**Re: Public Comment on behalf of the Village of Willowbrook and Village of Burr Ridge  
re: Illinois Environmental Protection Agency Draft Construction Permit to  
Sterigenics US, LLC Willowbrook I facility (Application No. 19060030)**

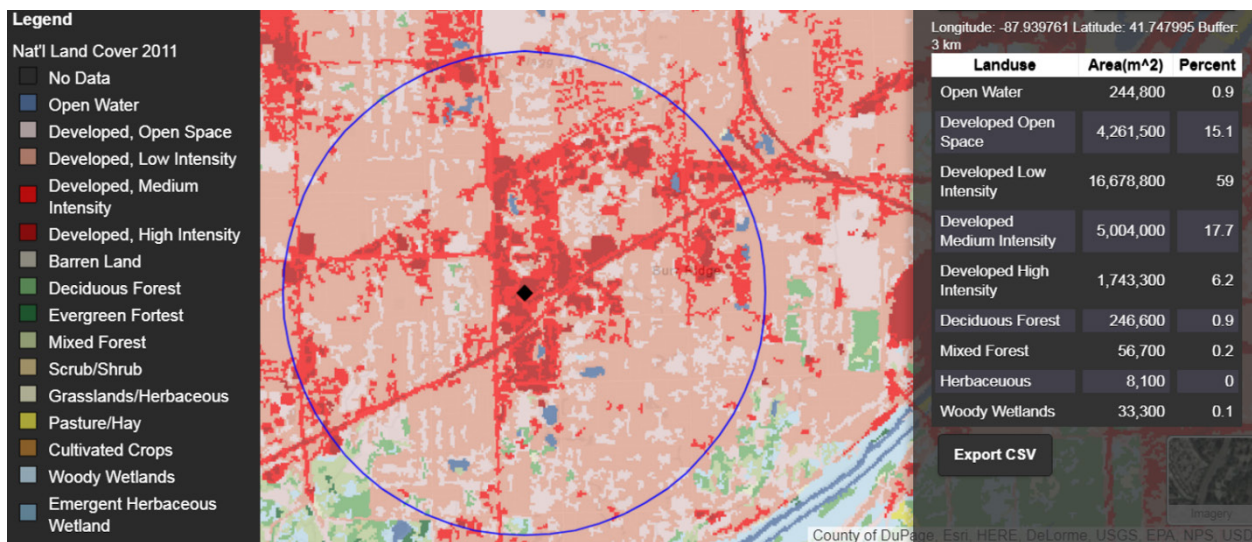
- a. Sterigenics also operates the Willowbrook II (WB2) facility located about 400 ft. northwest from the Willowbrook I (WB1) facility. While WB2 is not currently operational, that facility may recommence operation in the future. The potential emissions of EO from WB2 were not accounted for in the air dispersion modeling.

Given the close proximity of the two facilities and the potential for WB2 to operate in the foreseeable future, potential emissions of EO from WB2 must be accounted for (i) before IEPA issues the CP to the Facility to recommence operation of WB1, and (ii) as part of future ambient air dispersion modeling for the Facility as required under the Section 9.16(f) of the Act.
